Contract #: 04-0120F4Cty: SF/ALA Rte: 80 PM: 13.2/13.9File #: 69.25B**QUALITY ASSURANCE -- NON-CONFORMANCE REPORT****Location:** Changxing Island, Shanghai, PRC**Report No:** NCR-000109**Prime Contractor:** American Bridge/Fluor Enterprises, a JV**Date:** 04-Apr-2008**Submitting Contractor:** Zhenhua Port Machinery Company, Ltd (ZPMC), Changxing Island**NCR #:** ZPMC-0106**Type of problem:**

Job Name: SAS Superstructure

Subject: NCR No. ZPMC-0106

QUALITY ASSURANCE -- NON-CONFORMANCE REPORT

WELD NUMBER: SP359-01-002

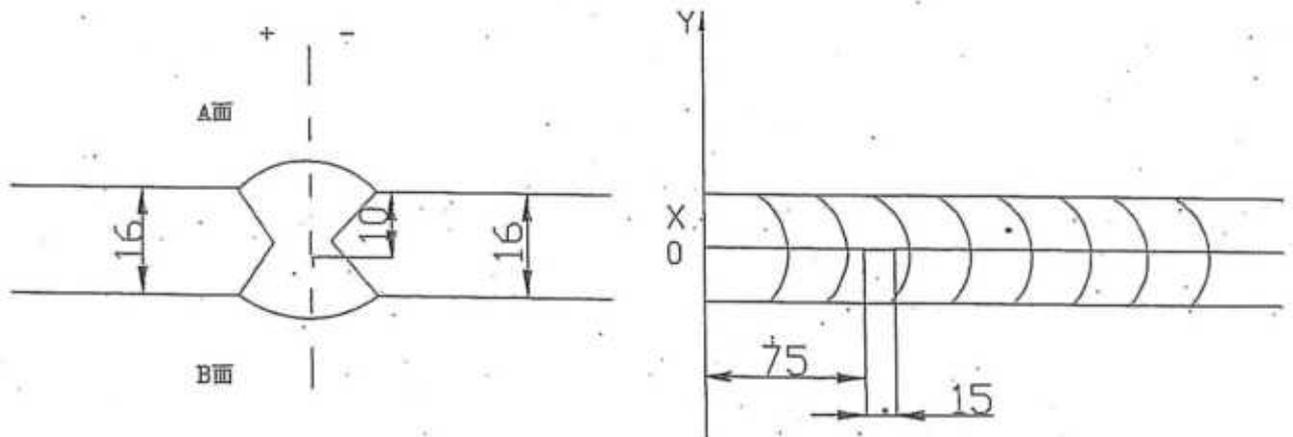
Rejected indication found by ultrasonic inspection at third time.
(UT探伤返修第三次。) SP359-01-002

- 1、焊工操作不当 Welders did not weld correctly.
- 2、焊道未清理干净 Clean Weld pass inadequately.

1. 从B面采用碳刨或打磨的方法去除焊缝缺陷;
 2. 准备一个正确得接头型式, 具体参照相应的返修WPS;
 3. 采用MT或其它无损检测方法保证缺陷完全被清除;
 4. 预热及焊接要求参照已批准的返修WPS执行;
 5. 将焊缝打磨与相邻焊缝平齐;
 6. 根据批准的车间图纸检查焊缝.
-
1. Gouge or grind to remove all the defects from the Face B.
 2. Prepare excavation according to the relevant repair WPS;
 3. Perform MT or other NDT methods of the area to ensure removal of the defects;
 4. Preheat and weld according to the relevant repair WPS;
 5. Grind the weld flush with the adjacent weld;
 6. Check the welds according to the working drawings.
